HORNSEA 3 WINDFARM

Review of Marine Hazards

Spirit Energy

Report No.: A13423, Rev. 3

Figure 4-4: Hornsea Three shipping and navigation study area (ref: Chapter 7 Environmental Statement Volume 2 – Infrastructure and other users)

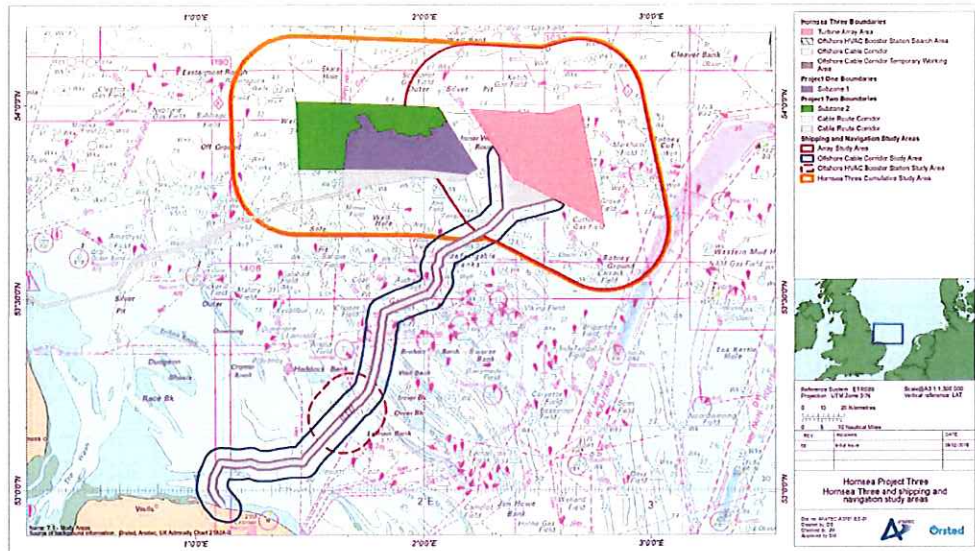
- Para 7.7.2.3 (Commercial Vessel Analysis) states that oil and gas vessels servicing drilling rigs were excluded from the analysis whilst vessels supporting permanent installations were retained. As many operators use the same vessels to support all activities this distinction could be misleading;

- In relation to fishing activity, it can be seen from the document that considerable fishing operations are prosecuted both in and to the East of the array area, in the vicinity of the Markham area. No meaningful assumptions or assessment has been made as to the displacement effect on this activity at any stage of the proposed windfarm, or the effect on Spirit Energy assets or operations;

Fig 4-5: Fishing activity in the study area of the proposed wind farm (ref: Chapter 7 Environmental Statement Volume 2 – Infrastructure and other users)

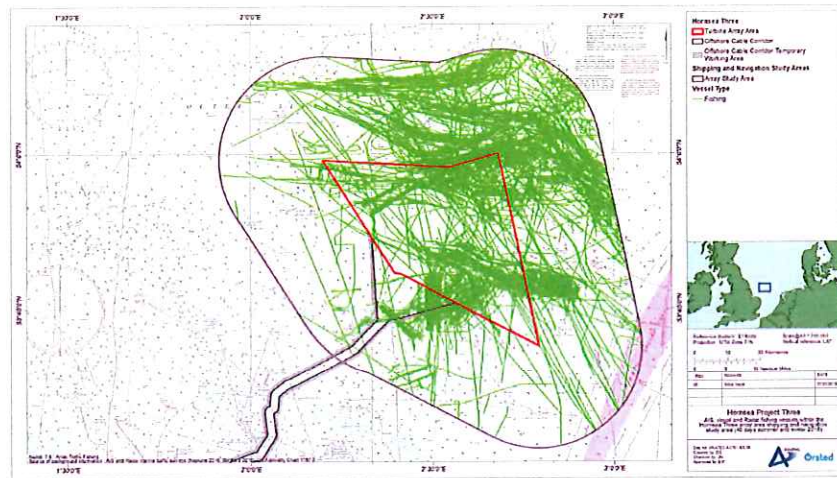
This document does not address the potential navigation and collision impacts of construction, O&M and de-commissioning activity associated with the proposed wind farm in detail. This is of particular concern in relation to displaced vessels (cargo and fishing) on the assets and operations of Spirit Energy in the Markham area.

Figure 4-6: Study area indicating Blocks where Spirit Energy (SE) are designated as Operator (ref: Chapter 11 Environmental Statement Volume 2 – Infrastructure and other users)

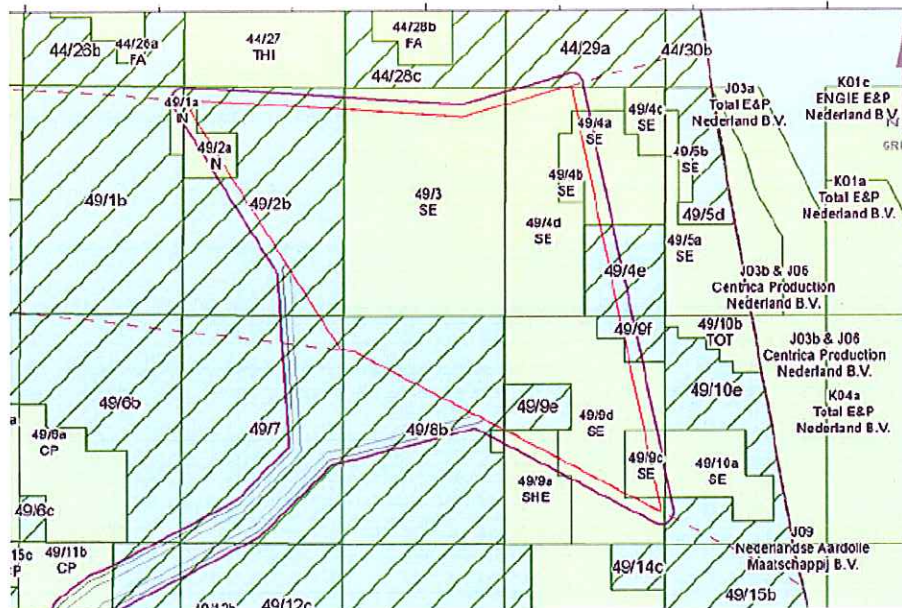
As shown elsewhere in this study, 1 km is an inadequate separation for a number of oil and gas activities including Jack up Rig Moves, and Crane Vessel spread mooring hence the EIA does not address hazards associated with current Spirit Energy activities of this nature.

Figure 4-7: Modelled radar shadow areas

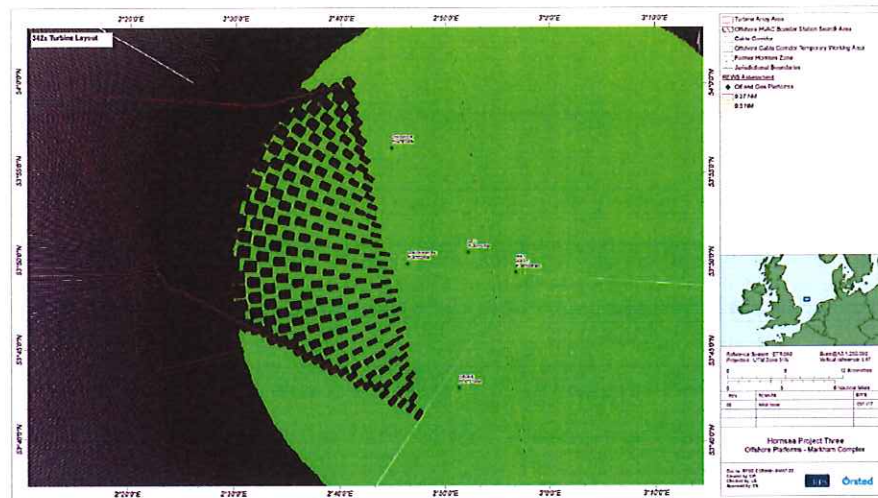
- The sensitivity for Spirit Energy with respect to REWS is already considered high in the EIA;
- The presence of proposed wind turbines in previously open sea areas will deviate vessels which may cause a change in CPA and TCPA alarms on oil and gas platforms protected by REWS. This topic is dealt with in depth in the EIA. The issue which should be of most concern is however the actual risk of vessel/installation collision. Whilst collision risk is to be dealt with in Document: HOW03_6.2.7_Volume 2-Ch 7 – Shipping and Navigation above, nowhere in the documents is the likely impact of diverted traffic in the restricted Markham area dealt with in adequate detail. This includes wind farm construction and O&M traffic, passing and displaced traffic, fishing vessels including displaced fishing vessels and oil and gas traffic. See Summary below.
